**Ancien couvercle Coupe-Légumes
For old vegetable slicer lid**

**Ancien variateur
Old variator**

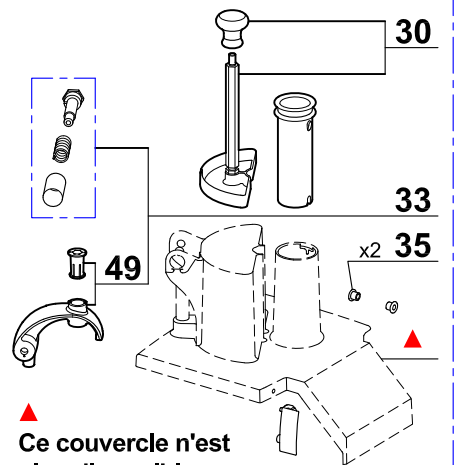
▲ Ce couvercle n'est plus disponible.
Commander l'index 29, vous recevrez le nouveau couvercle coupe-légumes complet.
This lid is no more available.
Order item 29, you will receive the complete new vegetable lid attachment.

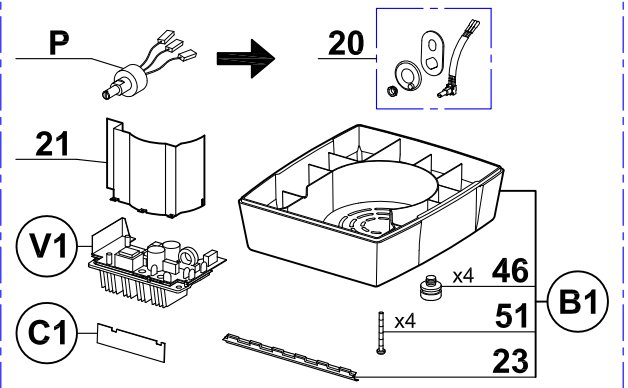
L'ancien potentiomètre P est remplacé par l'ensemble 20.
The old potentiometer P is replaced by the assembly 20.

L'ancien variateur n'est plus disponible, pour le remplacer commander le **kit de mise à niveau V1**.
Vous recevrez le nouveau variateur V2, le socle B2, la carte boutons C2, le support variateur 22, les vis et la notice.
Si vous avez déjà remplacé votre variateur par un nouveau, passez à la colonne "Nouveau variateur".

ATTENTION : Si votre appareil est équipé du potentiomètre P, alors commander en plus le nouveau potentiomètre 20.

The old variator is no longer available, to replace it, order the **upgrade kit V1**. You will receive the new variator V2, the base B2, the controls board C2, the variator support 22, the screws and the technical instructions.
If you have already changed your variator by a new one, use column "New variator".

CAUTION : If your machine is equipped with the potentiometer P, then order in addition the new potentiometer item 20.
